PLAN 3 The Cary - LH 'TRADITIONAL'

Lot 171 Duncan's Creek

80 Duncan's Creek Road
Lillington, NC 27546

PLAN 3 - THE CARY - LH
SINGLE FAMILY
Cover Sheet 'Traditional'

SLAB FOUNDATION 'TRADITIONAL'
SCALE: 1/8"=1'-0" ON 11x17, 1/4"=1'-0" ON 22x34

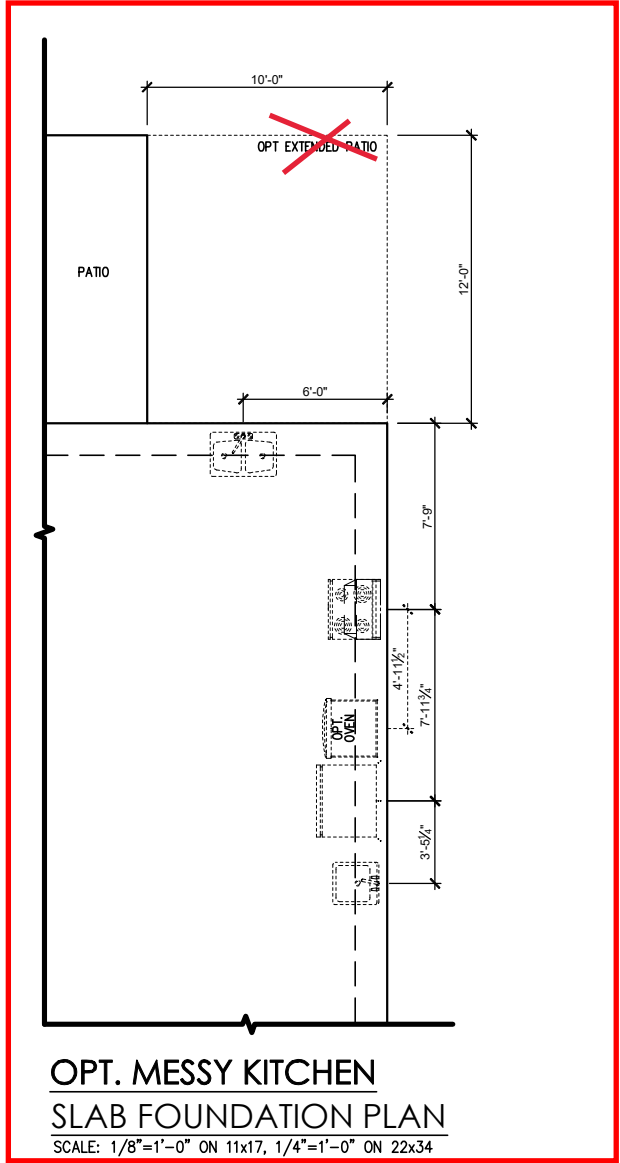
Insert Messy Kitchen
see Page 1.1.1a

FIRST FLOOR PLAN 'TRADITIONAL'
SCALE: 1/8"=1'-0" ON 11x17, 1/4"=1'-0" ON 22x34

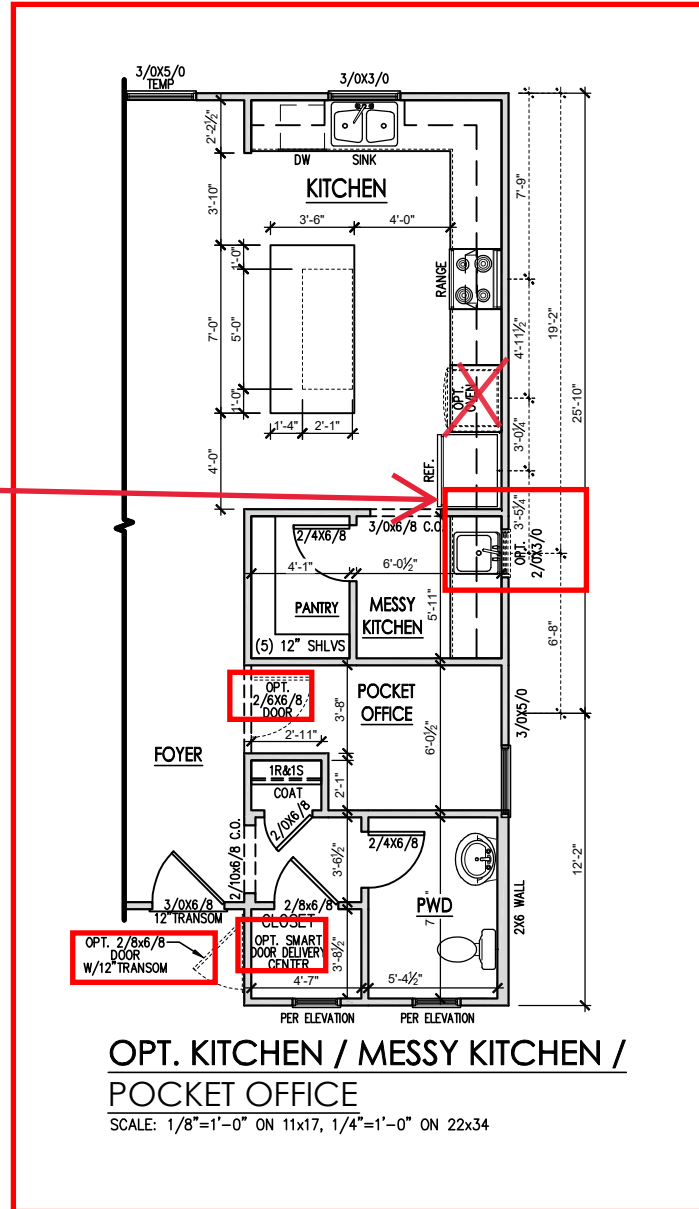
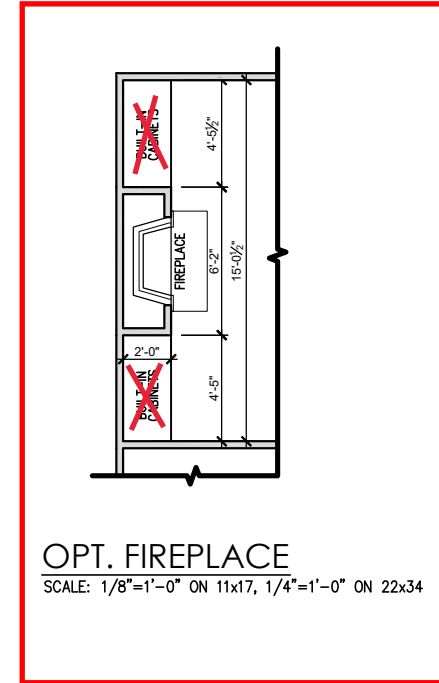
insert Messy Kitchen see Page 2.1.1a

Optional Fireplace see Page 2.1.1a

Opt Sink and Window @ messy

SECOND FLOOR PLAN 'TRADITIONAL'
SCALE: 1/8"=1'-0" ON 11x17, 1/4"=1'-0" ON 22x34

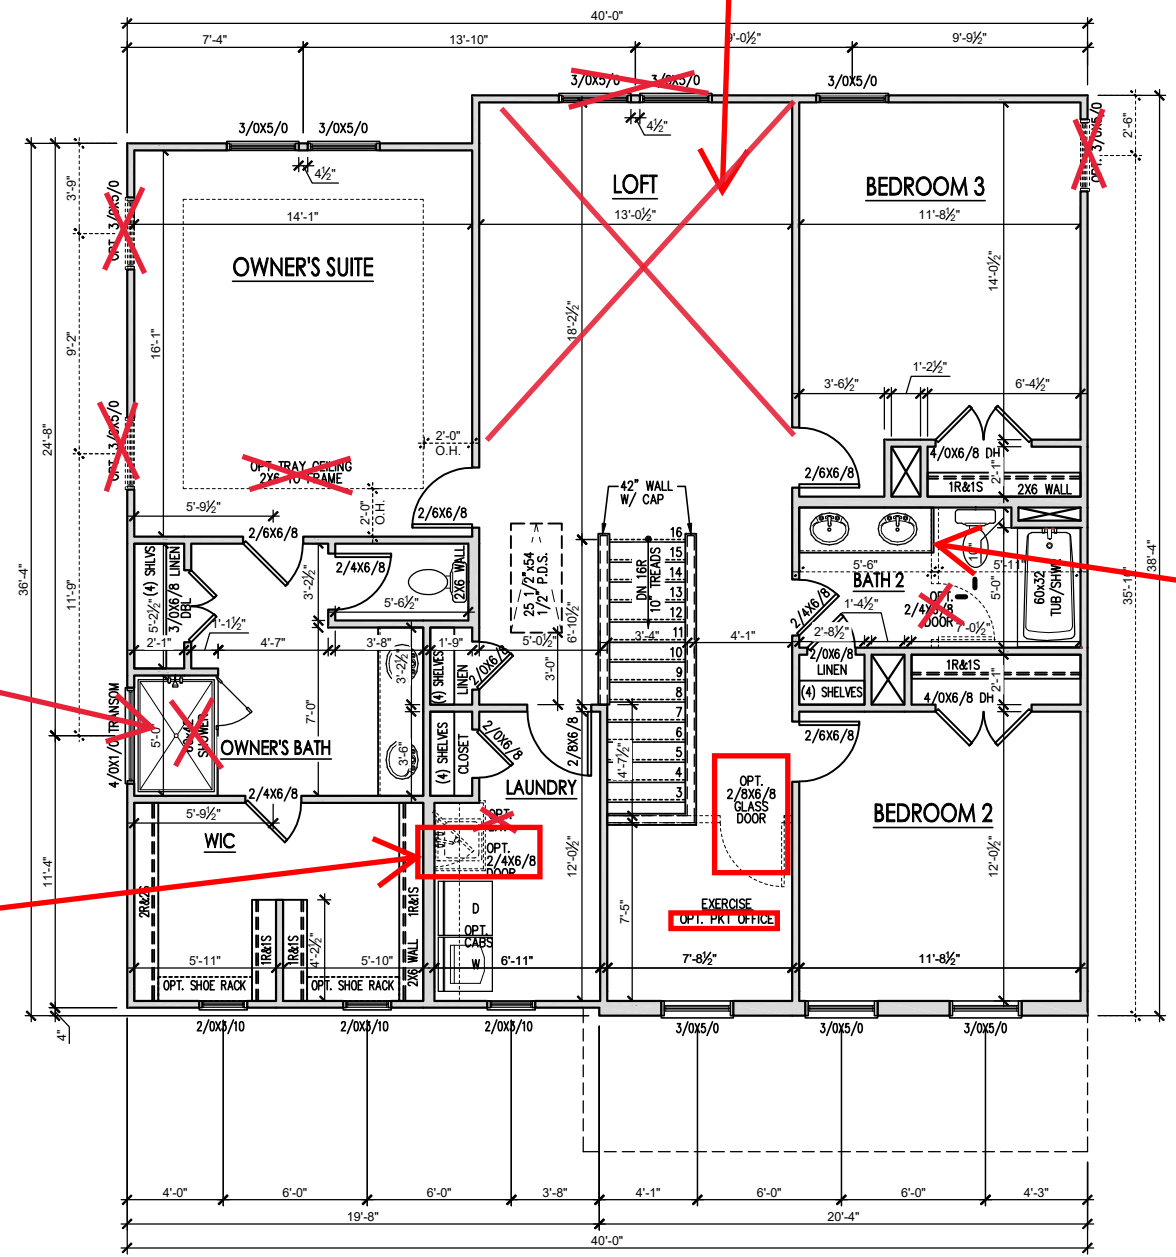
Insert Bedroom 4 Option with single window see Page 2.2.1a - no twin window

Insert Opt Shower w/Seat see Page 2.2.1a

No Laundry Tub
Install Opt door from WIC to Laundry

remove wall separation

OPT. MESSY KITCHEN
SLAB FOUNDATION PLAN
SCALE: 1/8"=1'-0" ON 11x17, 1/4"=1'-0" ON 22x34

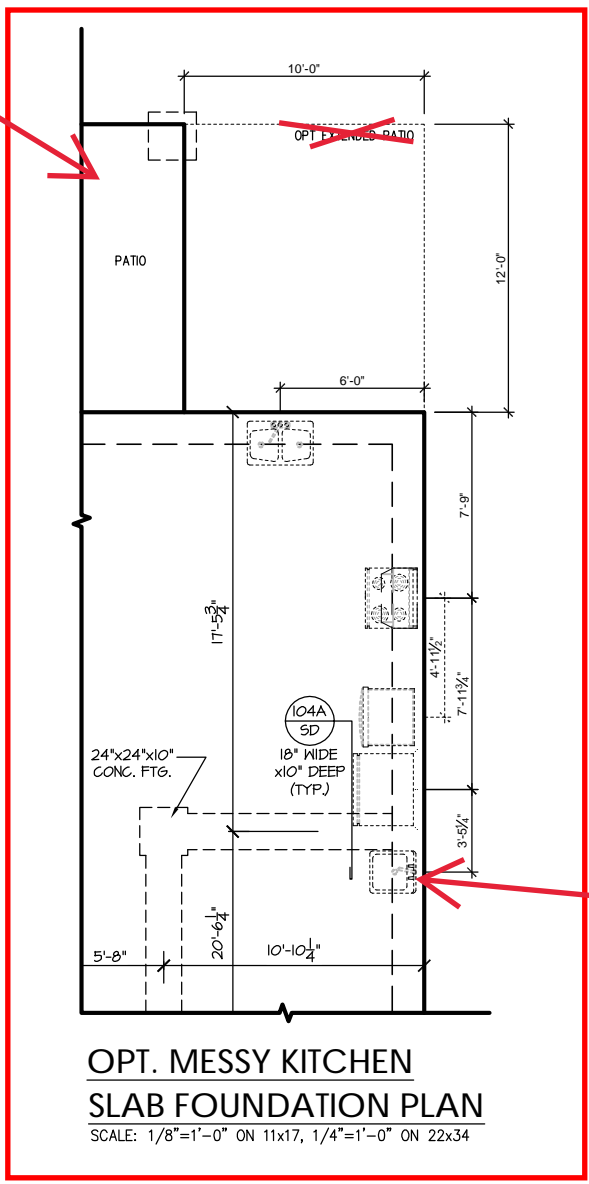
yes to Opt Messy Sink

OPT. 2-CAR SIDELOAD GARAGE

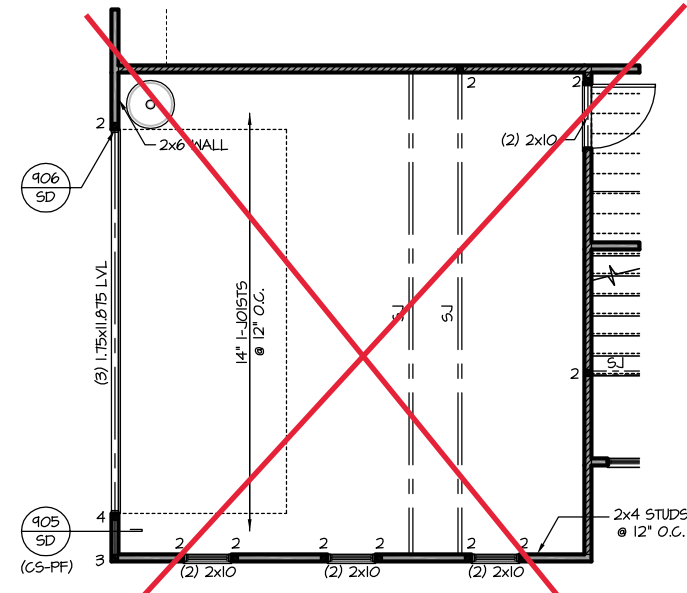
No Side Load Garage

SECOND FLOOR PLAN 'TRADITIONAL'
SCALE: 1/8"=1'-0" ON 11x17, 1/4"=1'-0" ON 22x34

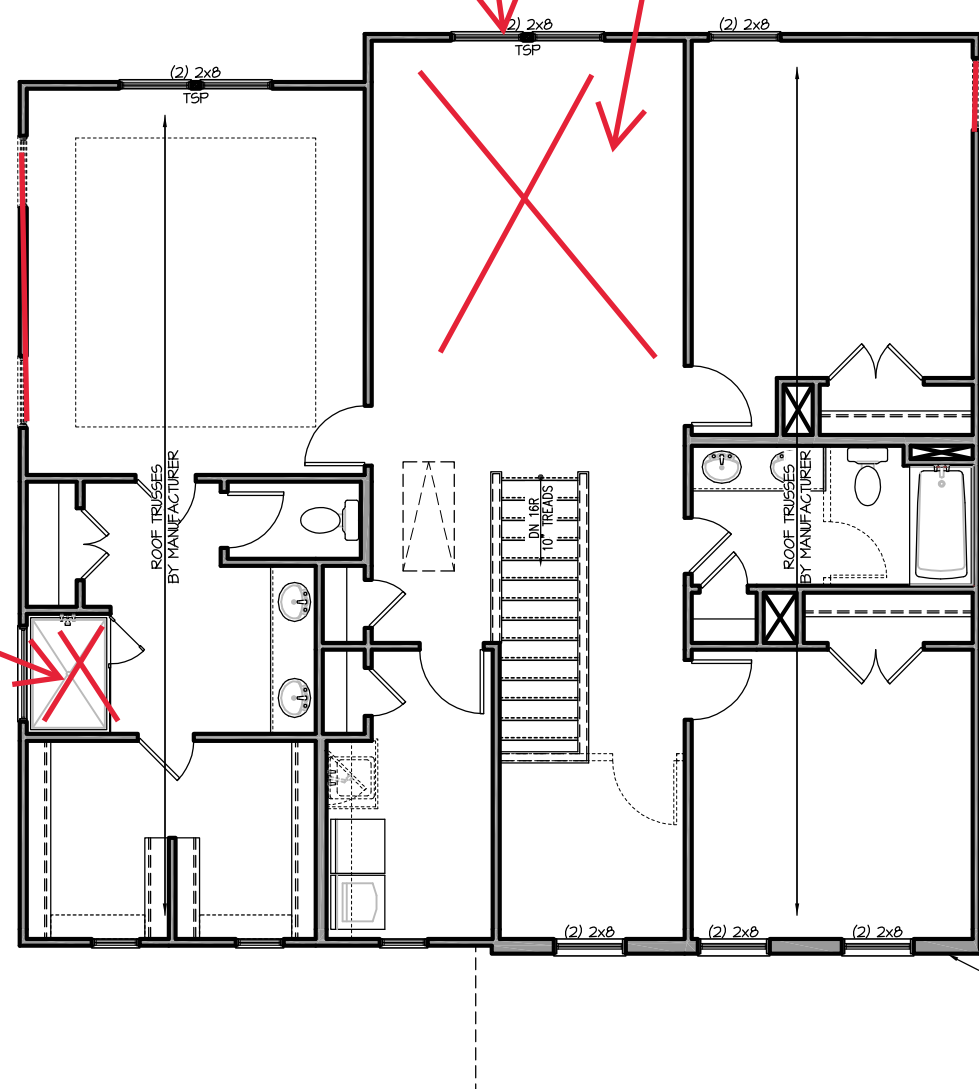
Single Window, no Twin per Opt. Bedroom 4

Opt. Bedroom 4 see Page S-2.1.1

Opt. Shower w/ Seat see Page S-2.2.1

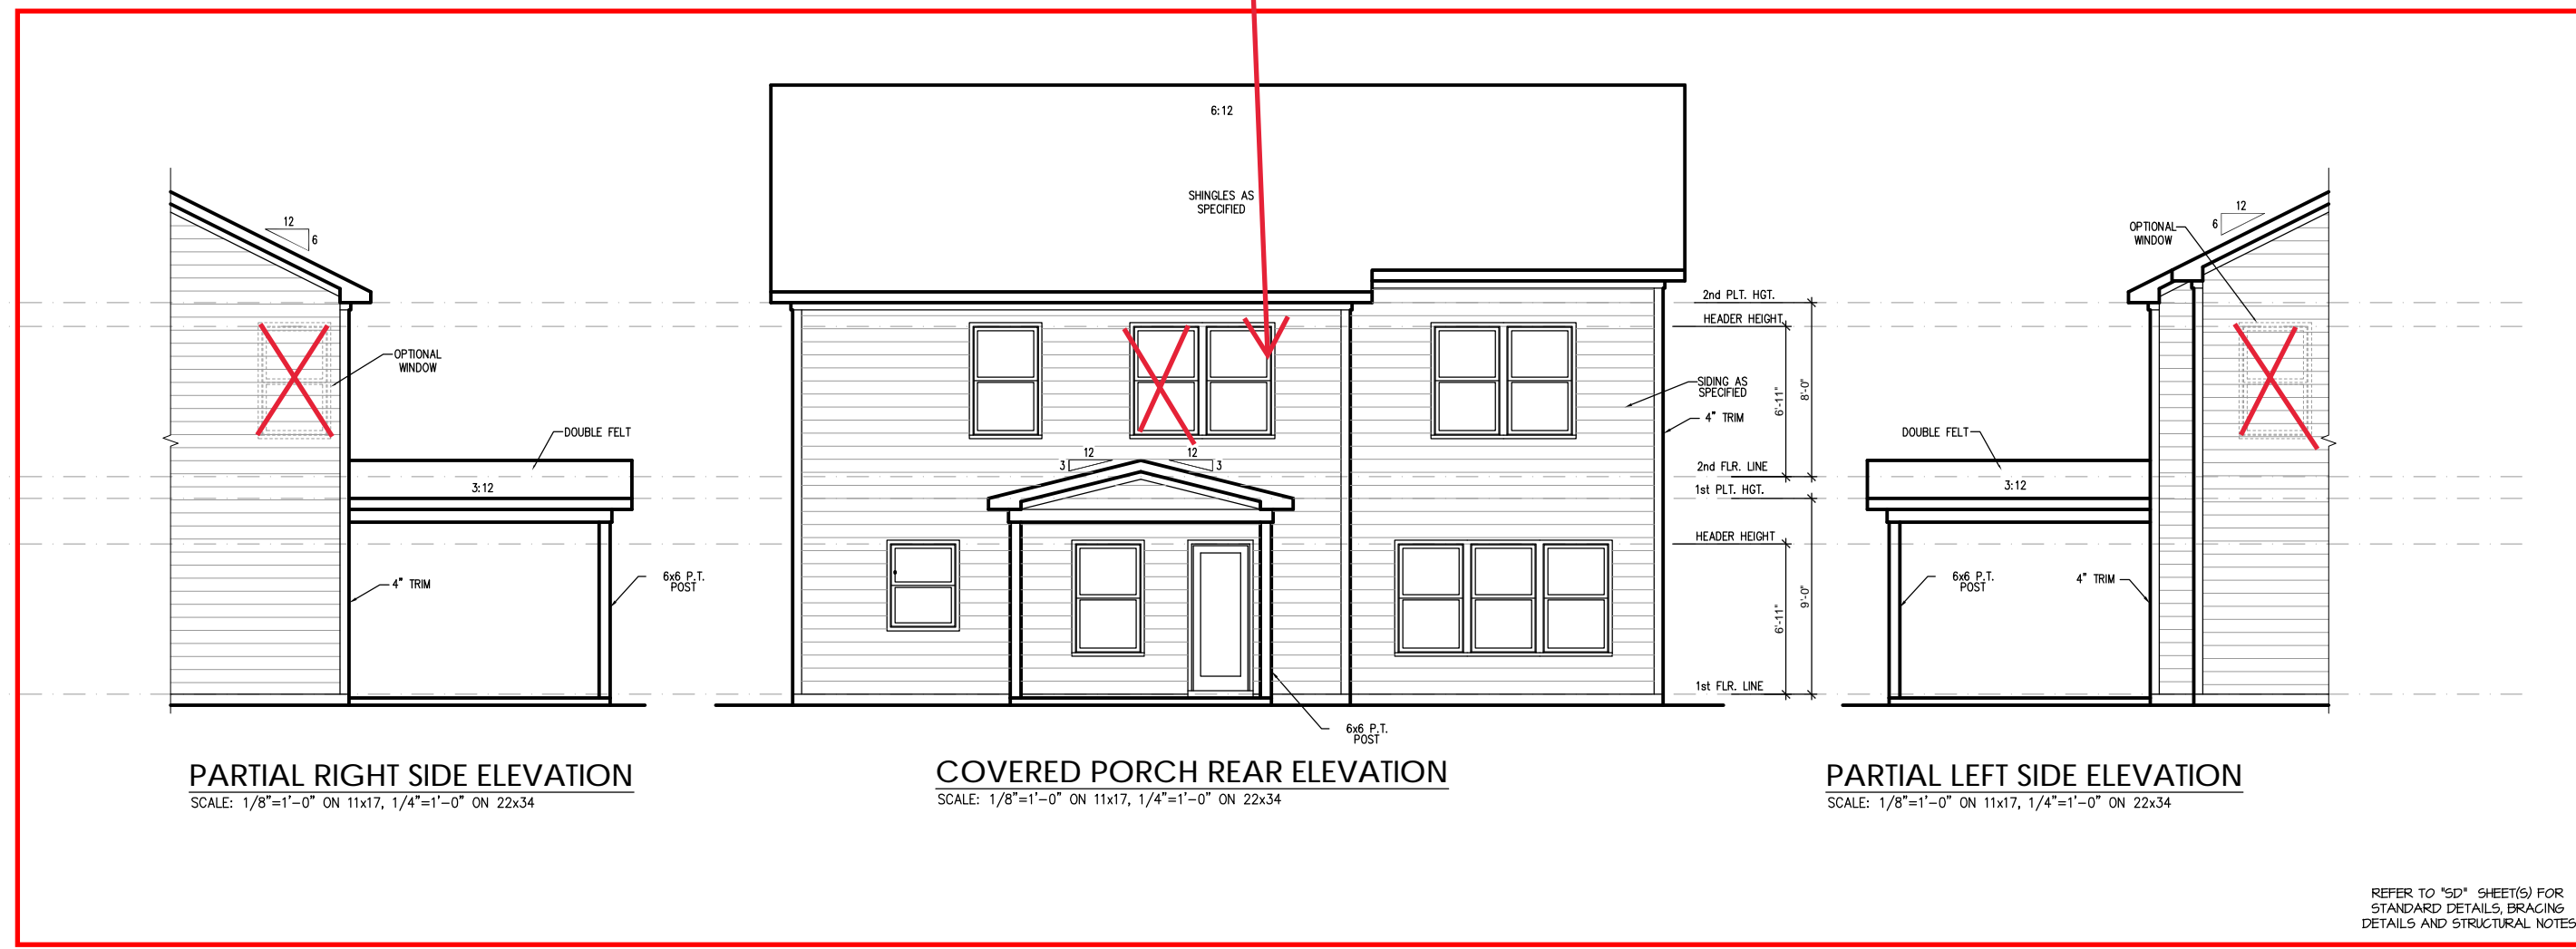
Single Window - no Twin per
Opt. Bedroom 4 - 2nd Floor
Single Window Spacing
Page 2.2.1a
